Architect's Supplemental Instructions

Wilma P. Mankiller Health Center
Expansion
Stilwell, OK

ASI Number: Bid Package 02 ASI 006

Construction Documents – ASI 06 – Wilma P. Mankiller Health Center Expansion

04 PRECAST PANEL DETAIL
3" = 1'-0"

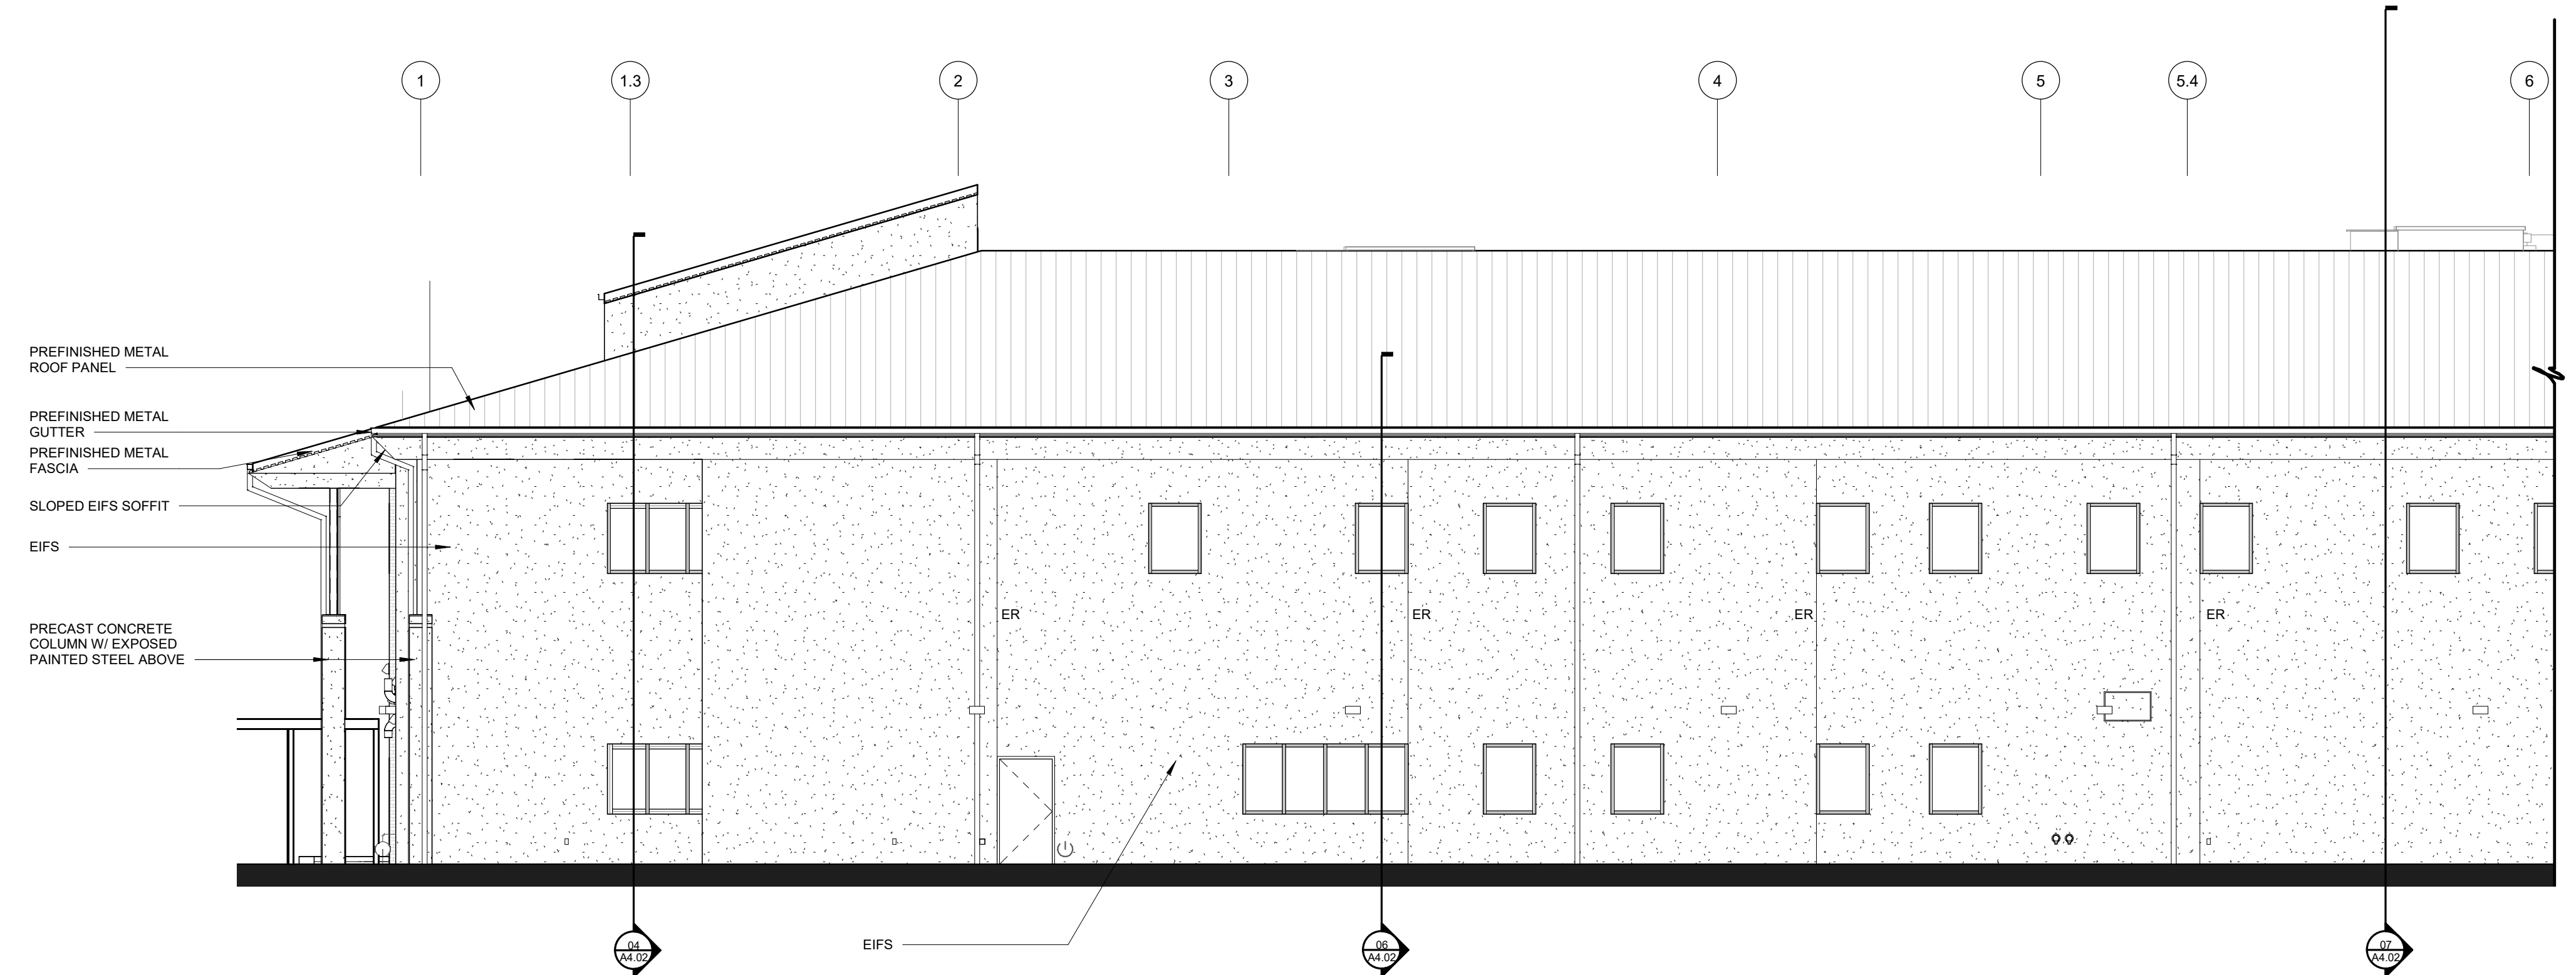
A2.03

1. Enlarged Elevations added

SHEET NUMBER: A5.10

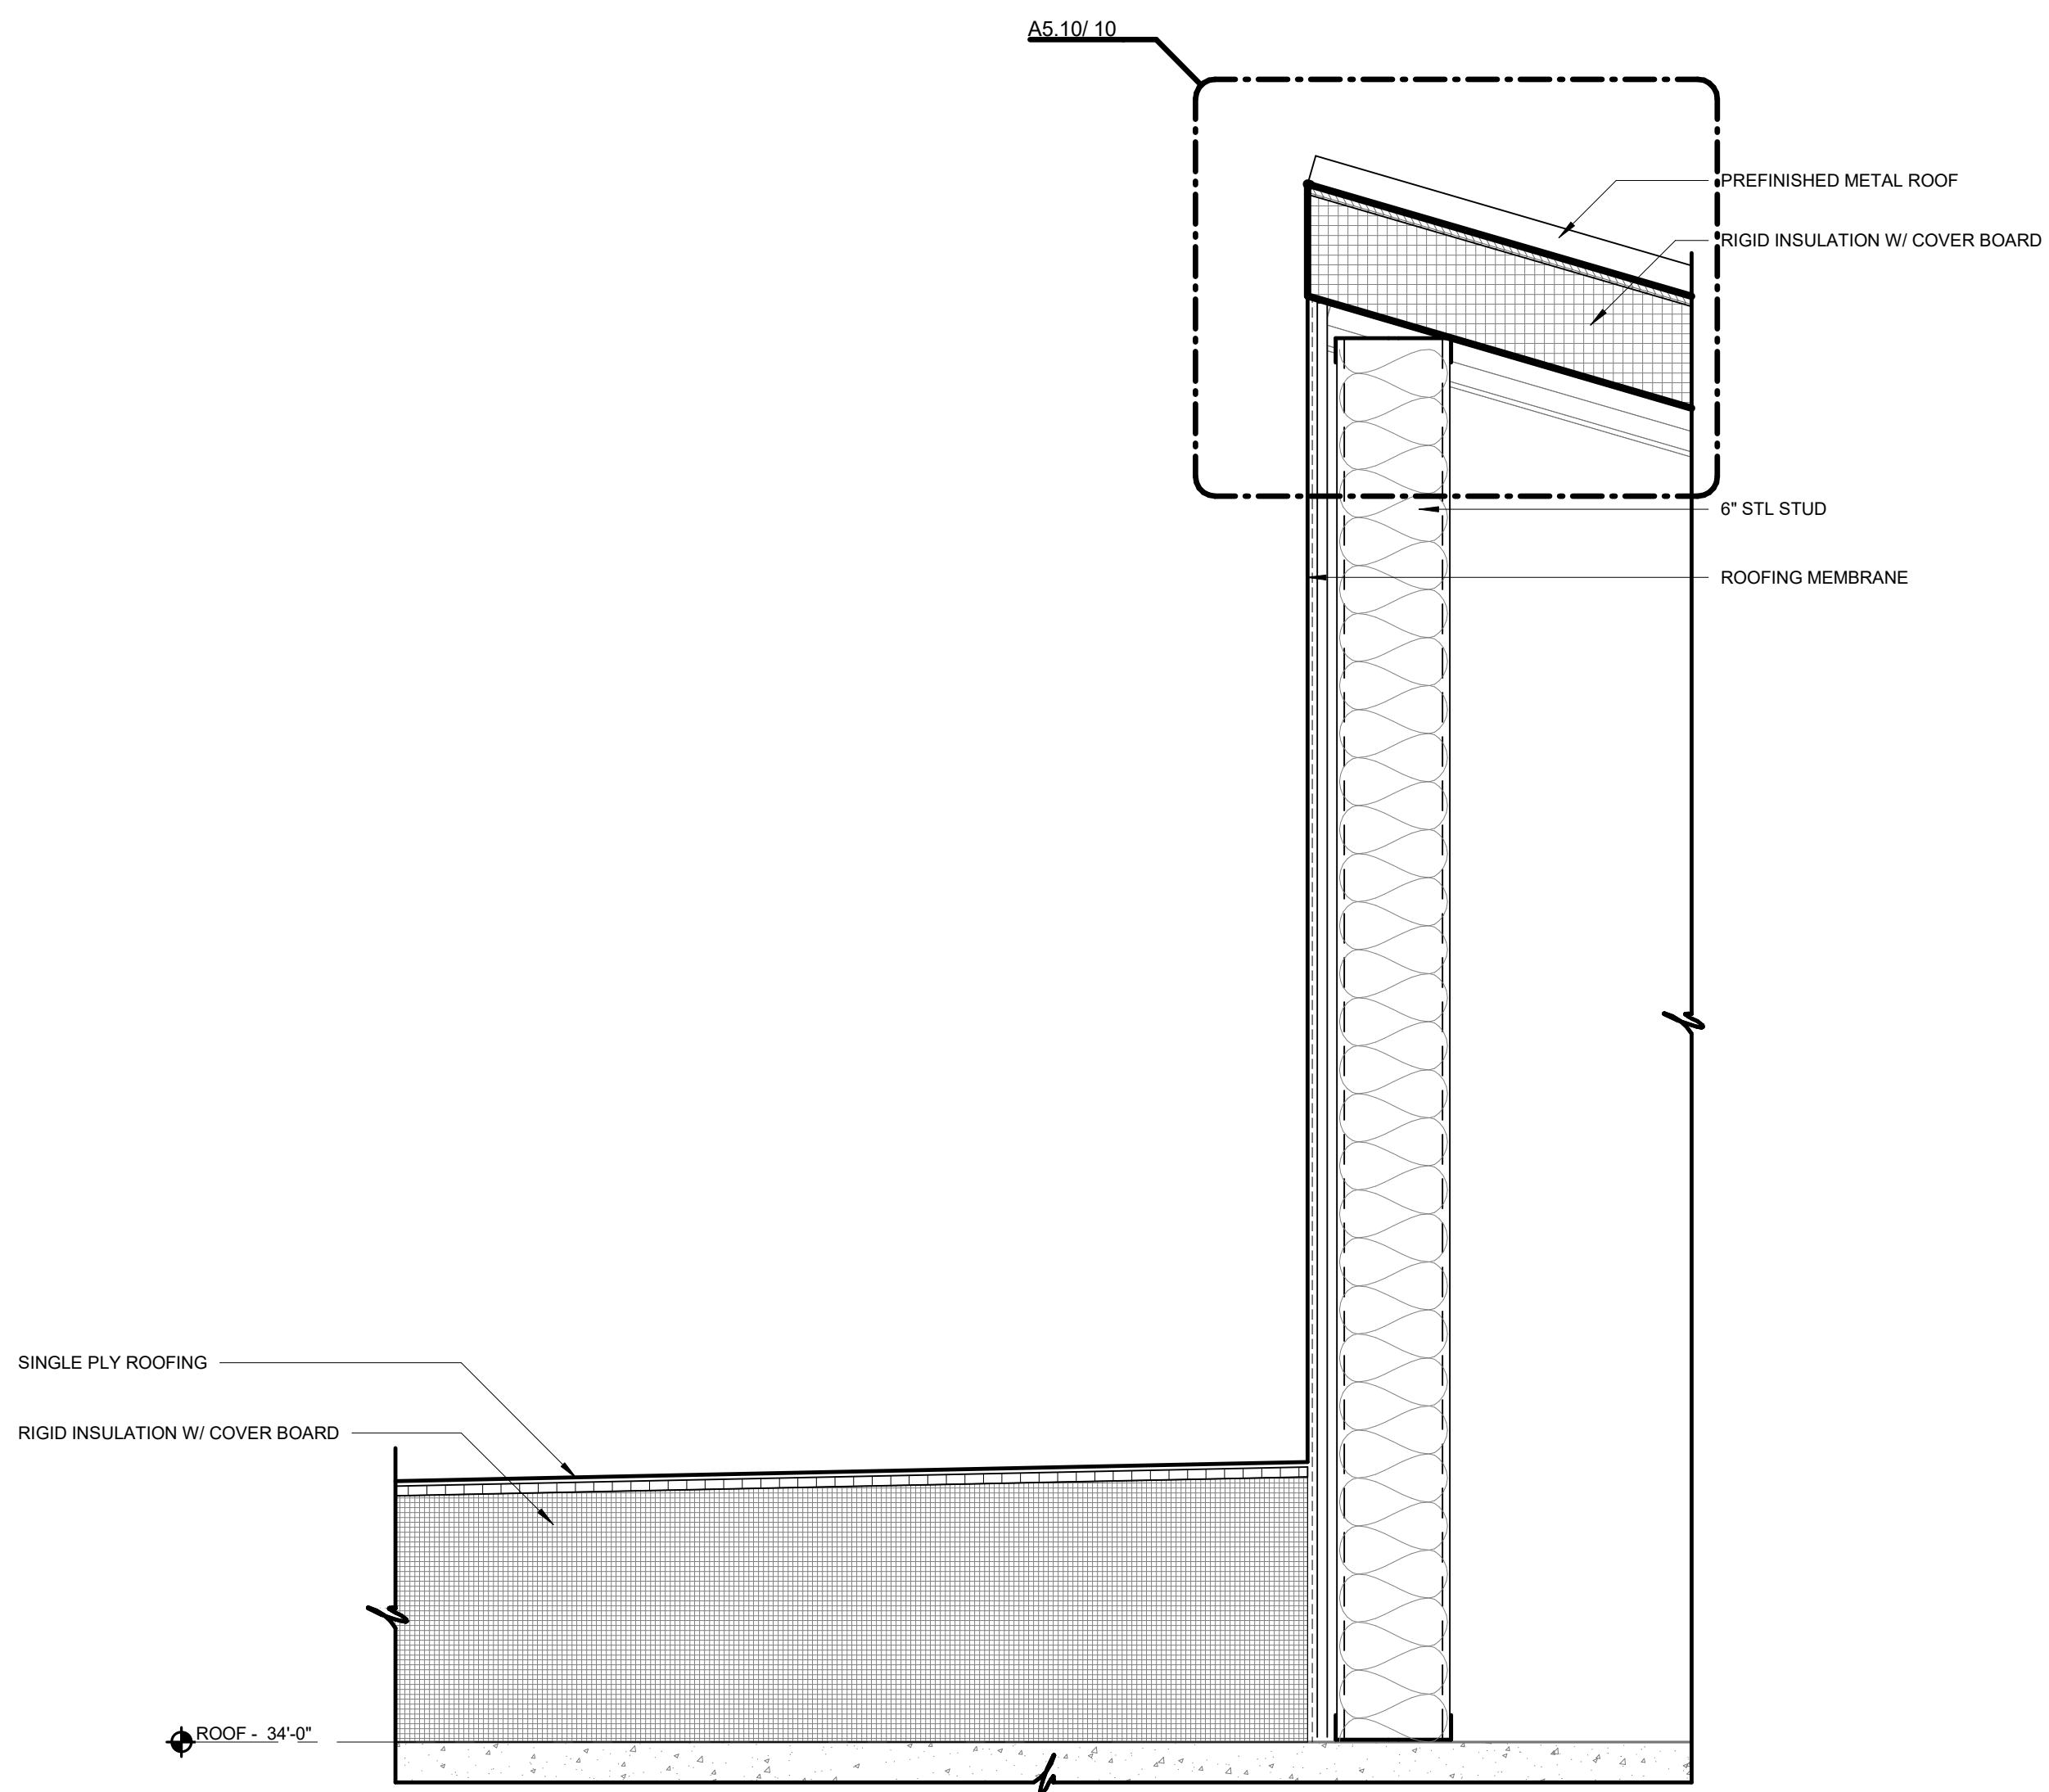
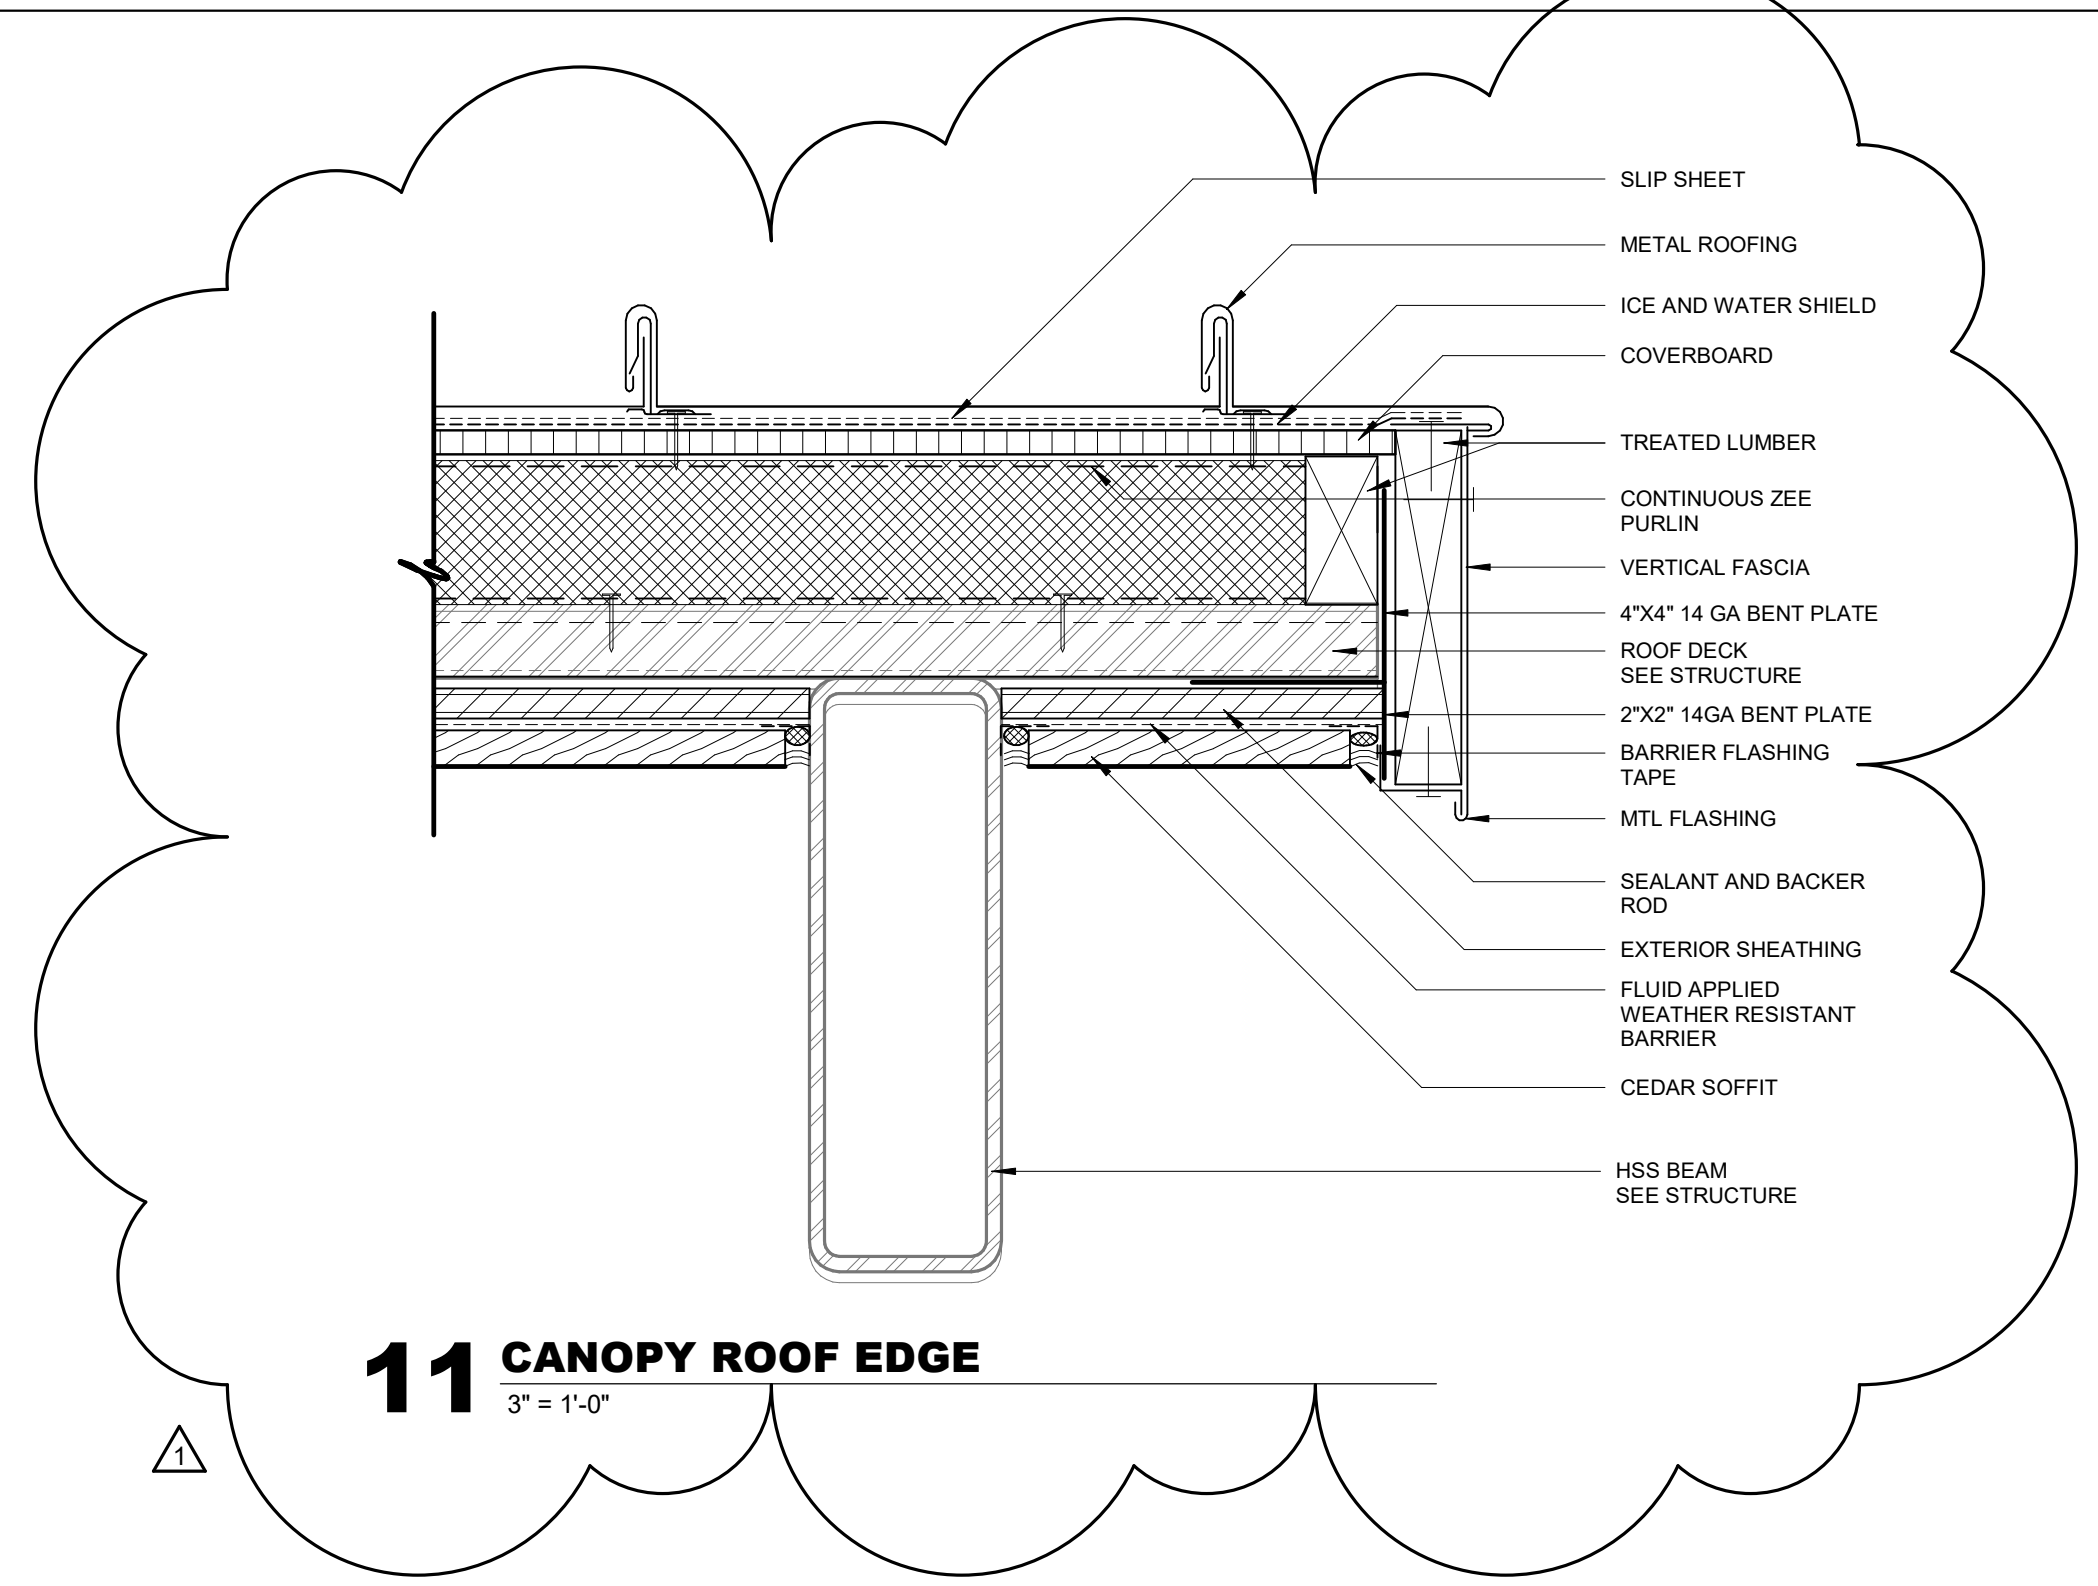
A5.10

1. Canopy Edge Detail added
